SUMMARY OF CONCERNS IN RELATION TO THE PROPOSED NORTHCONNEX TUNNEL

SECTION A: THE CONNECTIVITY OF NORTHCONNEX SOUTHERN VENTILATION FACILITY AT THE SOUTHERN INTERCHANGE, THE SOUTHBOUND TUNNEL IN PARTICULAR

MOTORWAY OPERATIONS COMPLEX - SOUTHERN VENTILATION FACILITY - SECTIONS
M1-M2-5000-DR-JD-0525

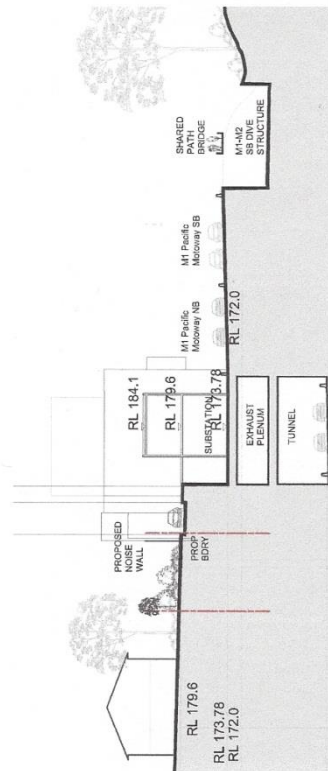
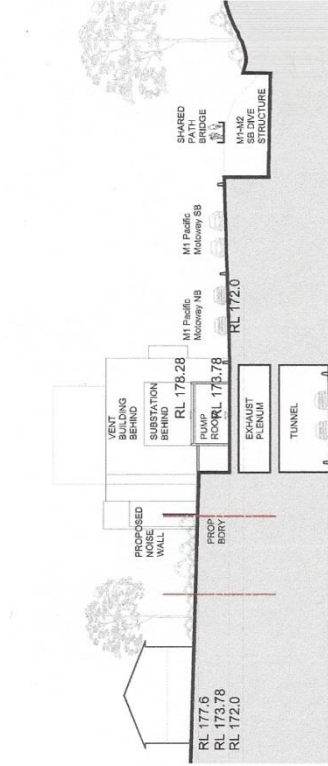
5. *EIS Volume 4, Technical working papers - Urban Design, 6.0 Operational Ancillary Facilities*
EIS Page 99 there is the diagram "Motorway Operations Complex – Southern Ventilation Facility – sections. *Page 10 below* The diagram has the cryptic label "Connection to tunnel TBC". What does TBC stand for? To be considered? Why is tunnel singular? Which tunnel is the diagram referring to northbound or southbound? There is no diagram showing any connection from the Southern Interchange ventilation facility to either the northbound or the southbound tunnel in any way
AND YET

- Diagrams need to be provided showing the inter-relation between the shaft, the ventilation outlet and the motorway operations centre with a clear description of what is to be constructed and how it will operate.
- The community needs irrefutable evidence that the polluted air from the southbound tunnel exit portals will not be allowed to flow like an invisible sewer through West Pennant Hills, North Rocks, Carlingford and Beecroft.

MOTORWAY OPERATIONS COMPLEX - SOUTHERN VENTILATION FACILITY - SITE SECTION 1-1
M1-M2-5000-DR-UD-0713

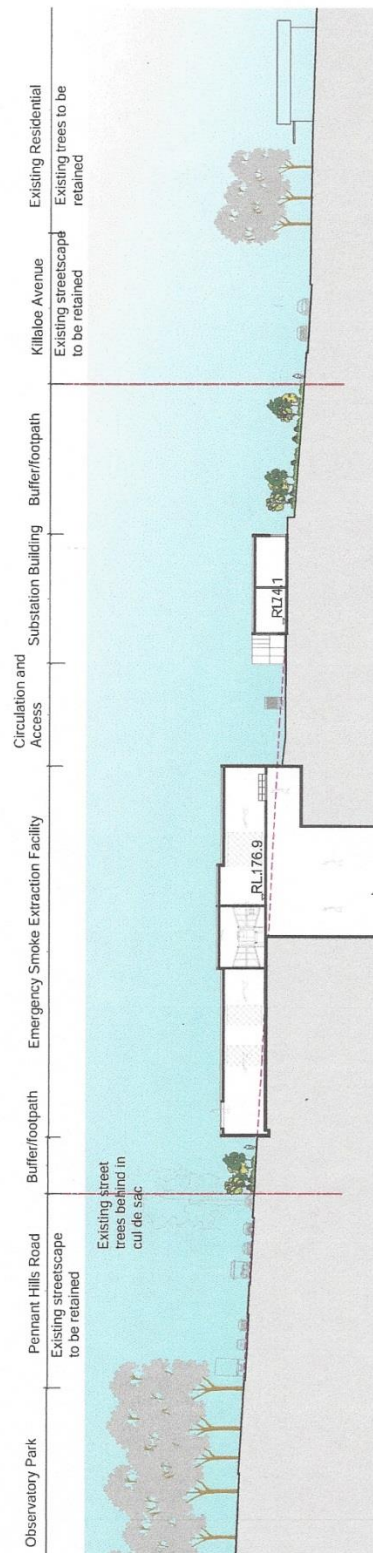
6. *EIS Volume 4, Technical working papers Urban Design, 8.0 Landscape Design*
EIS Page 176 is the diagram "Motorway Operations Complex – Southern Ventilation Facility – Site 1-1". *Page 13 below* The diagram does not show any connection to either the northbound or southbound tunnel. In the same Landscape Design section, EIS Page 182 is the diagram "Wilson Road Tunnel Support Facility –Section" *Page 14 below* which clearly shows the connection to the tunnels. In the same Landscape Design section, EIS Page 189 is the diagram "Northern Ventilation Facility – Landscape Concept Section". *Page 15 below* This also clearly shows the connection to the tunnels.
